Request for Class II Permissive Change

FCC ID: 2APFC-HF367XA

Data: March 1st, 2022

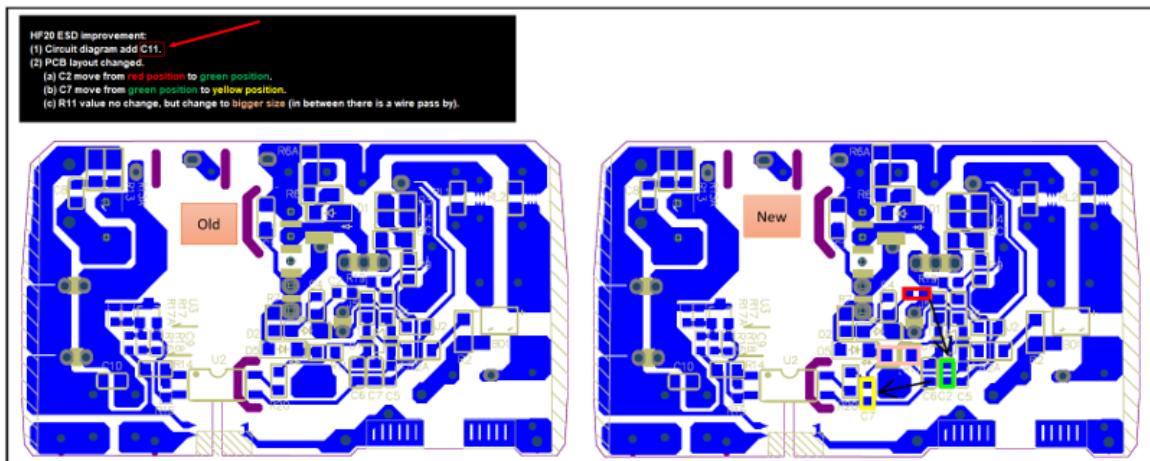
1. PCB of power supply HF20 was updated.

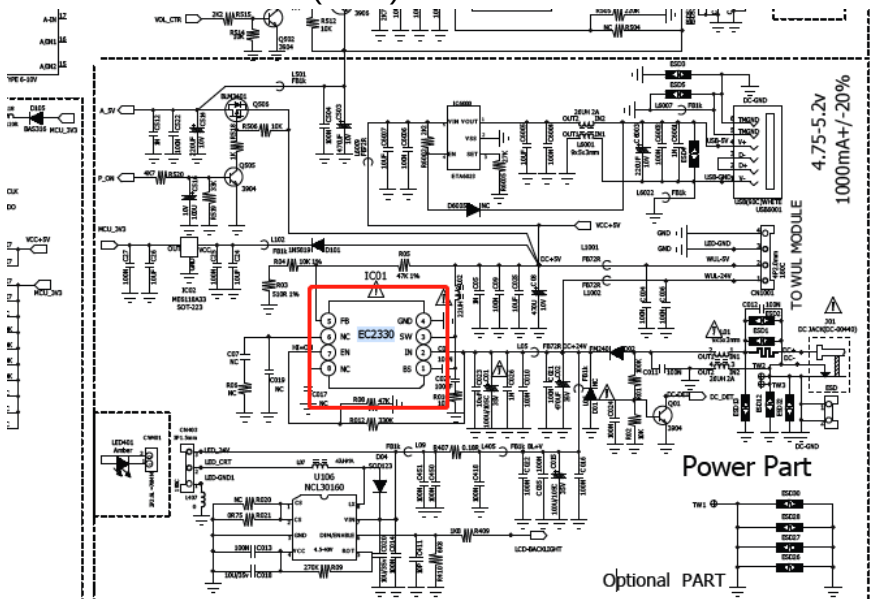
2. an alternative DC-DC (IC01) EC2330 was added.
